**APP/M1900/W/21/3278097**  
**WITNESS STATEMENT**

**Groundwater management plan and public water resources matters  
significant to  
The proposed quarrying activity at the Hatfield Aerodrome**

By:	Michael Hartung - Member of Ellenbrook Area Residents Association
Date:	17 October, 2021
Use:	Appeal <b>APP/M1900/W/21/3278097</b> (Nov. 2021) on rejection of proposed quarrying activity, Hatfield Aerodrome
Witness called by:	Ellenbrook Area Residents Association (EARA) and Smallford Residents Associations (SRA)

The map below shows just how close the bromate plume is to the public water supplies. Map of bromate plume & PWS (007).

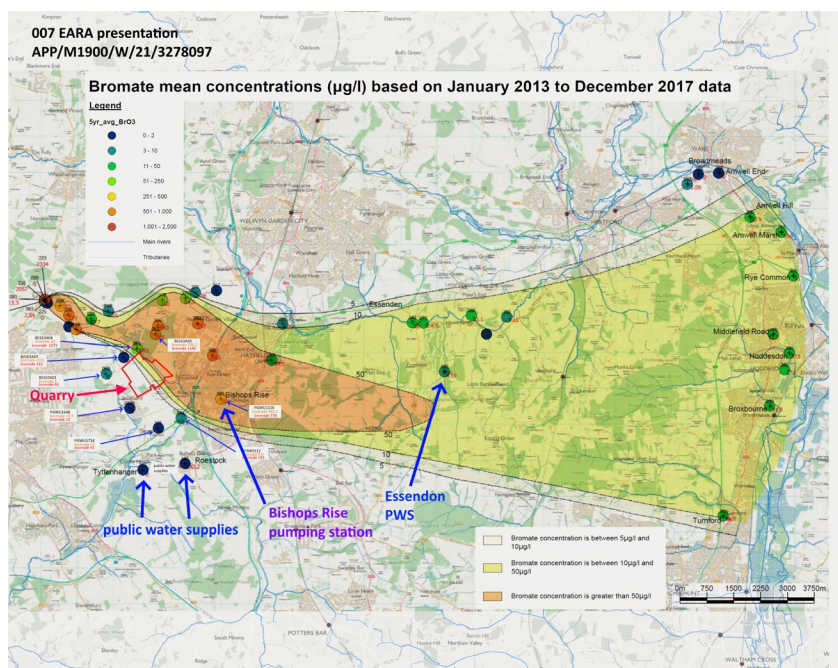
- 3.2.1 The bromate plume has already affected the land and consequently the water supply in Hertfordshire. Two local pumping stations have already

been affected by the plume; one in Hatfield (Bishops Rise) had to be closed when it was realised this was putting contaminated water into the public water systems, and one in Essendon which is closely monitored to ensure that the drinking water remains below WHO guidelines. If the plume moves in a southerly direction due to quarrying activity, there is a threat to the remaining uncontaminated water pumping stations at Tyttenhanger and Roestock. We do not believe that any risks to the remaining supplies in the area should be taken, particularly as Affinity Water have recently stated that there is potential for water shortages.

- 3.2.2 We recognise the importance of the remediation work (circa 2008) to remove the bromate that has been undertaken by Affinity Water, who operate the pumping station at Bishops Rise Hatfield. However, over the past 10 years this remediation work has sadly failed, despite the huge financial cost and more importantly the ongoing loss of trillions of litres of precious and scarce water and this has made no noticeable difference to the level of contamination. A Drought Consultation document (008) explains the relationship between drought and wasting water at Bishops Rise to scavenge bromate.
- 3.2.3 However, we have to put the protection of our water supplies first and not have a plan to manage the consequences if / when the plan fails. We are aware that Affinity Water will not put contaminated water into the public
